MEMORANDUM

SUBJECT: East Grand Avenue Overlay District Zoning Study – Public Testimony and Revised Proposed Amendments

DATE: May 10, 2024

IMAGE B- (2x) 2-bed & (2x) 1-bed units

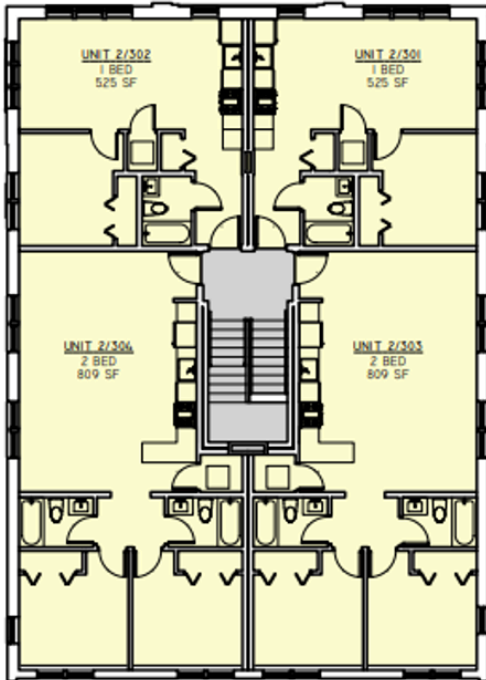
Image B on the left below shows the 3rd floor of the building without stepbacks includes two 2-bed units and two 1-bed units . **Image C** on the right shows the stepbacks as proposed would result in the loss of >50% of the built square footage and two 2-bed units. **Under these conditions, no project would be built.**

In a development with the stepbacks pictured on the right:

- The cost of land, design, utilities, fire protection and facade would stay the same
- The cost of framing would increase with added complexity
- The rent generated by the project, which is required by lenders and investors, would decline due to the loss of multiple units

1. **Sustain Saint Paul's highest-priority proposed change, Side & Rear Yards:** Stepbacks should only apply to front yards, or corner-side yards on projects with >200' of street frontage (e.g. 150' typical lot depth + >50' Grand Ave frontage). Rear yards should not have any step back requirement.

** 800 Grand Ave, 3 stories (0 setback from both)*

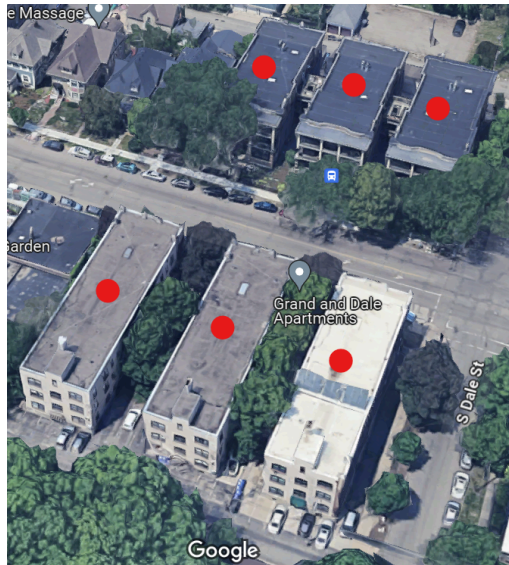
Appendix: Examples of existing Grand Avenue buildings east of Virginia that would be prohibited to build under the current proposed overlay district

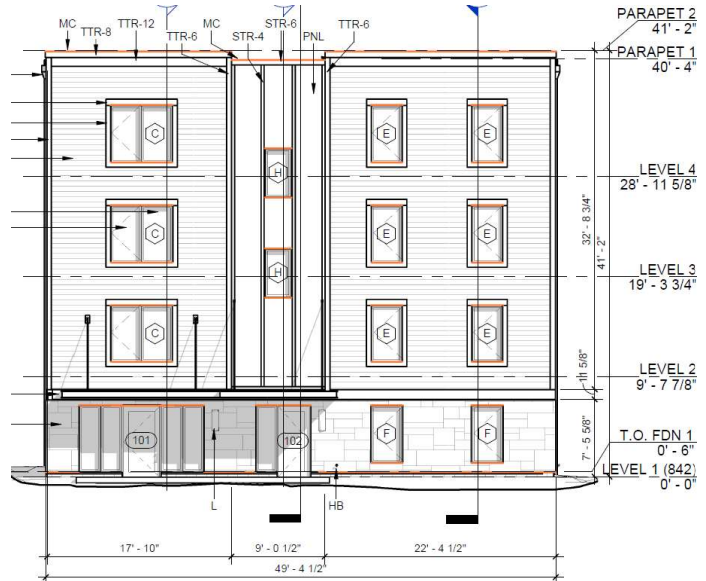
At 41' tall, this is abnormally short for a 4-story building. Each floor has only 8' ceilings, and thinner trusses were used between floors (**at great additional expense**) to shorten the building height.

Buildings with ground floor commercial, like we want on Grand Avenue, are **universally taller**. In a more typical building, the **step back would therefore occur starting on the 2nd floor...exacerbating the impacts illustrated below.**

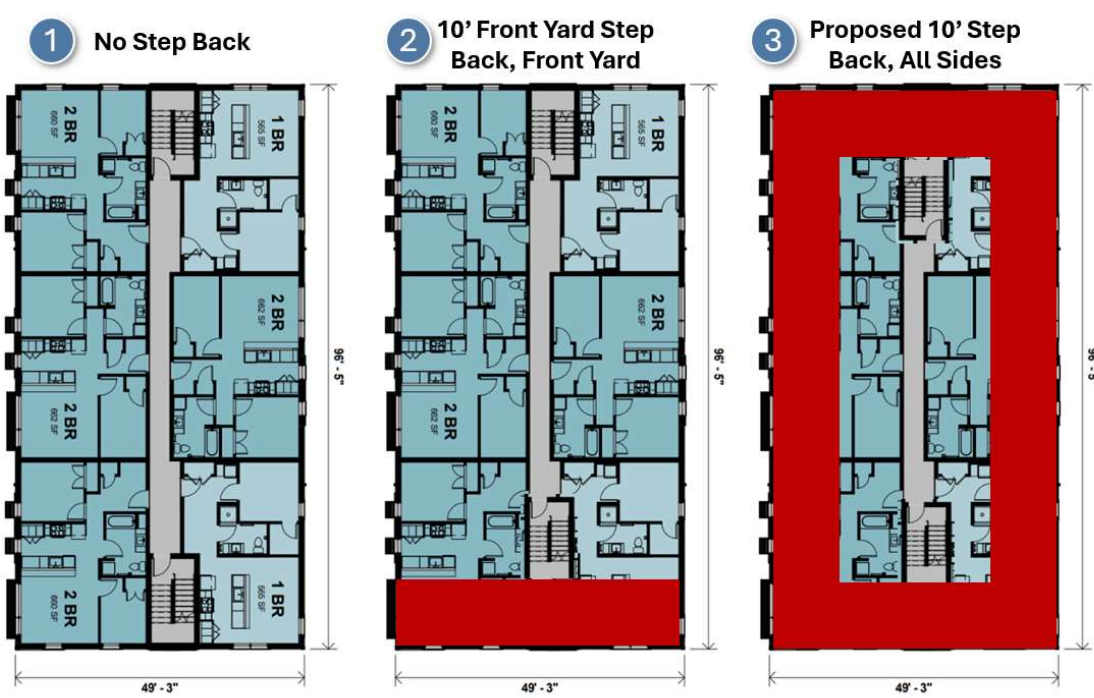
Image #3 below shows the current stepback proposal of 10' on all sides of the building. The 4th floor is mostly hallway & stairs, with poorly functioning, bowling-alley shaped units. In this scenario, no 4th floor would be attempted. **With only 3 stories of units, and the high cost of land on Grand Avenue, the project would be economically inviable. No bank or investors would fund it.**

In Image #2, we see that having a 10' step back on just the front yard of the building would **eliminate 2 entire homes**. The loss of these units still **make the project economically inviable.**
